Access Compliance Report

Public Rights-of-Way

(Curb Ramps)

Intersection ID: 6518	Main Street: MISTY_CREEK_DR	Cross Street: WAYSIDE_CT	Location:	N
ADA ID: FC8EAA700D15	Ramp Type: Perp	Initial Pass/Fail: Fail	Overall Compliance: No	Severity Score: 22.5
Codes/Mitigation Info/Possible Solution		Field Measurements/Component Compliance

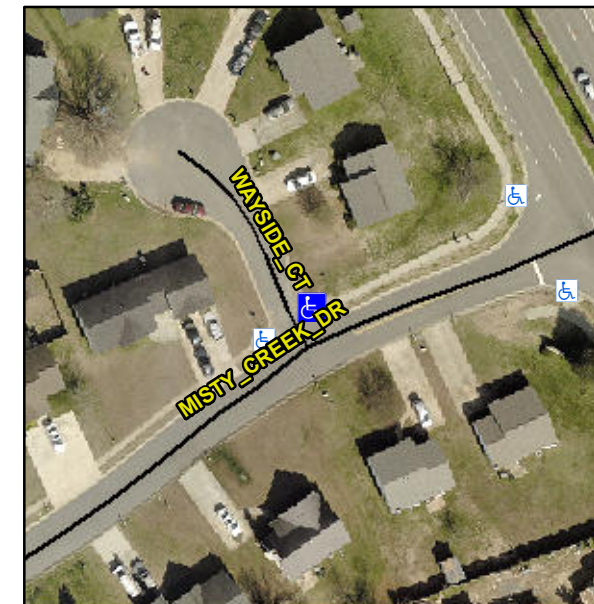
Not Found, R304.5.1, R304.2.2, R304.5.3

Compliance	Description	Data	Compliance	Description	Data
N/A	Ramp Length (in)	94.5	No	Ramp Slope (%)	10.0
No	Ramp Width (in)	42.0	No	Ramp XSlope (%)	4.7
N/A	Flare Type LT	N/A	N/A	Flare Type RT	N/A
N/A	Flare Slope LT (%)	N/A	N/A	Flare Slope RT (%)	N/A
N/A	Flare Traversable LT?	N/A	N/A	Flare Traversable RT?	N/A
N/A	Landing Length (in)	N/A	N/A	DWS Provided?	N/A
N/A	Landing Width (in)	N/A	N/A	DWS Contrast?	N/A
N/A	Landing Slope (%)	N/A	N/A	DWS Length (in)	N/A
N/A	Landing X Slope (%)	N/A	N/A	DWS Full Width?	N/A
N/A	Landing Curb? (Y/N)	N/A	N/A	DWS Offset (in)	N/A
N/A	Shared Landing?	N/A			
N/A	Gutter Ponding?	N/A	N/A	Gutter Slope (%)	N/A
N/A	Gutter Lip Ht (in)	N/A	N/A	Gutter X Slope (%)	N/A
N/A	Painted X Walk1?	No	N/A	Painted X Walk2?	N/A
	X Walk 1 Direction	To SW		X Walk 2 Direction	N/A
N/A	X Walk 1 Width (in)	N/A	N/A	X Walk 2 Width (in)	N/A
	X Walk 1 Slope (%)	2.0		X Walk 2 Slope (%)	N/A
	X Walk 1 X Slope (%)	4.3		X Walk 2 X Slope (%)	N/A

Remove & Replace Entire Ramp.
